Oakdale West Estate MOD 2

*State Significant Development
Modification Assessment
(SSD 7348 MOD 2)*

April 2020

Figure 8 | Proposed Stage 1 Layout

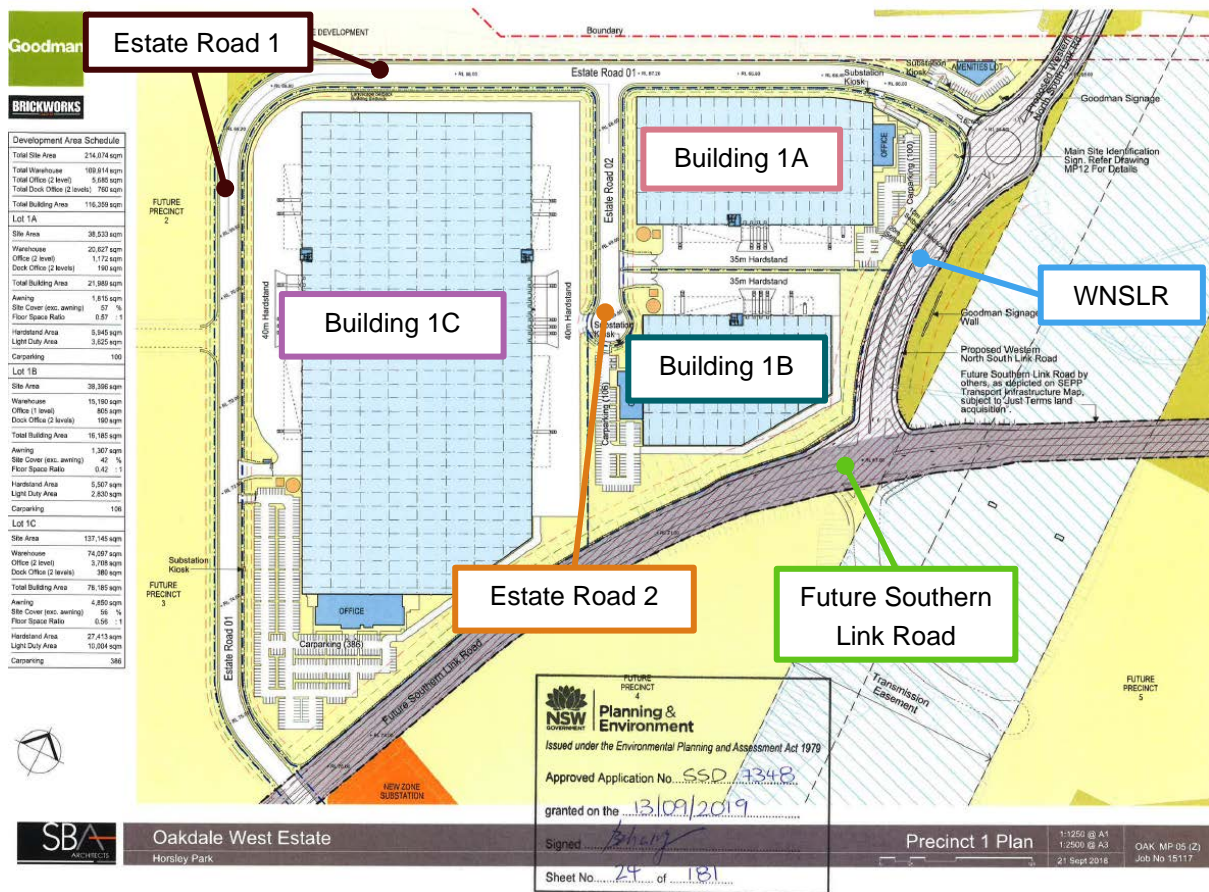
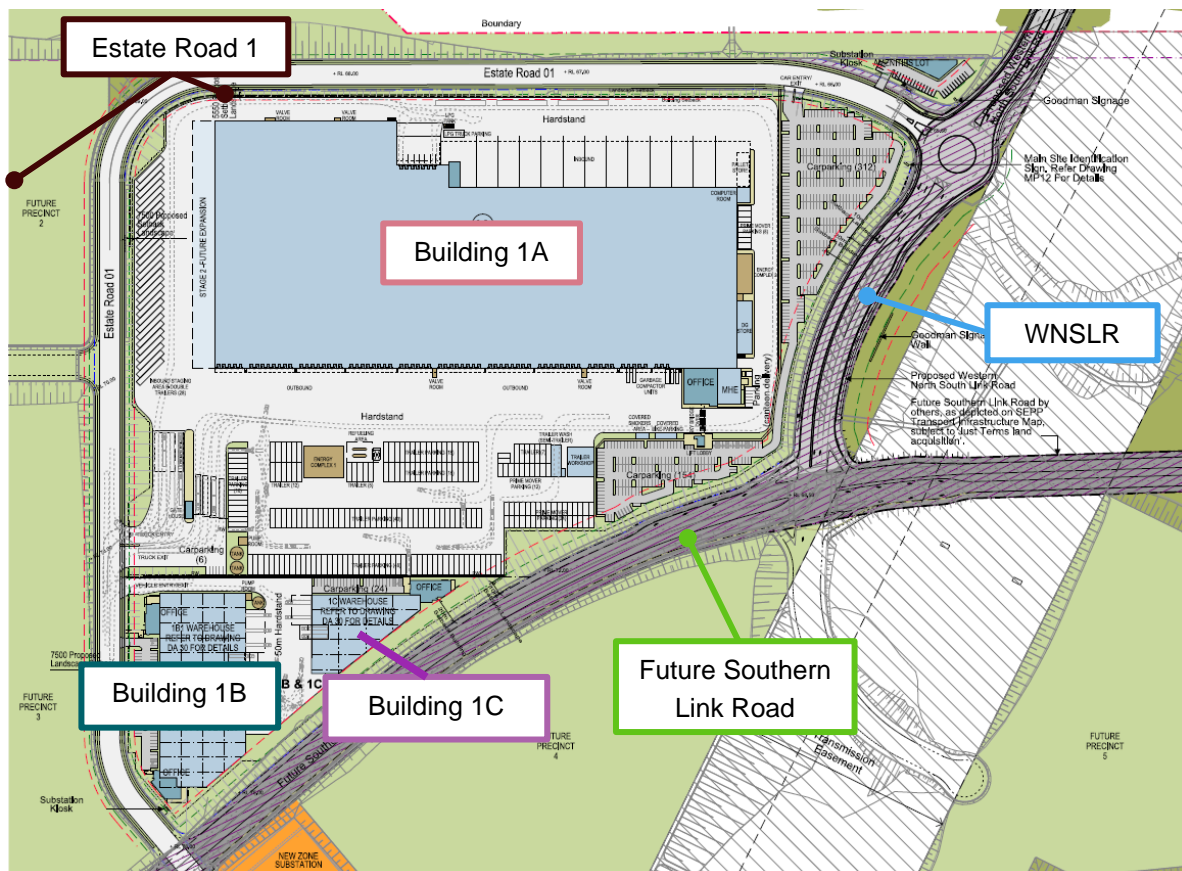
The RtS included changes to the design of Stage 1 to address the issues raised by Council and TfNSW. Changes were made to remove the driveway access points from the WNSLR and instead provide access from the internal estate road. The layout of Lot 1B and 1C were revised to increase the landscape setbacks to the SLR.

Figure 12 | Approved and Proposed Noise Wall

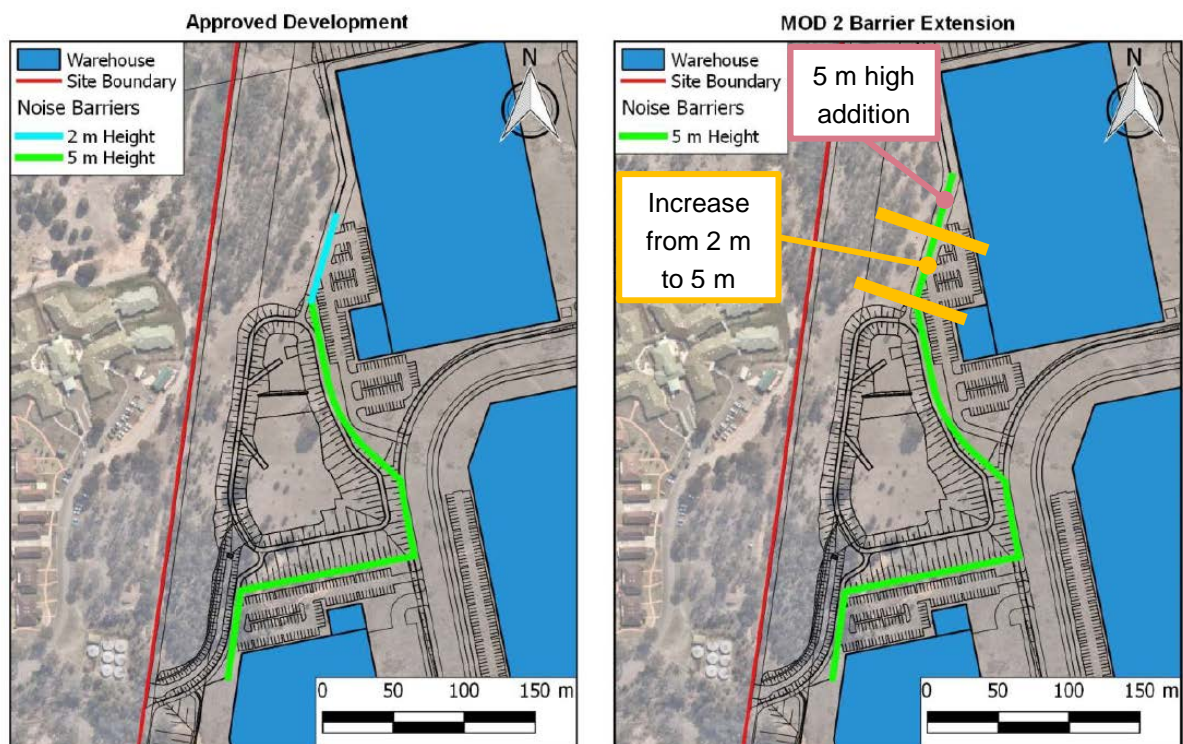
The noise barrier approved as part of Stage 1 works is scheduled for completion by October 2020. The Applicant's Noise Impact Assessment (NIA) for MOD 2 indicated the location and height of the barrier would need to change to ensure Building 1A would not exceed the noise limits at the western receivers. The noise barrier would be extended further north and the 2 m high section would be increased to 5 m, consistent with the remainder of the barrier around the sediment basin. **Figure 12** shows the approved barrier and the barrier proposed for MOD 2.

On 3 April 2020, the Department approved MOD 3 for the OWE, which further modifies the location and height of the noise barrier to attenuate development within Stage 2. The barrier will be constructed in accordance with the approved MOD 3, as it supersedes the design for MOD 2 and has considered cumulative noise impacts from MOD 2, MOD 3 and the fully developed OWE. The Department has also recommended a condition requiring the noise barrier to be installed in accordance with MOD 2, if for

some reason MOD 3 does not proceed. This would ensure noise from the development complies with the noise limits.
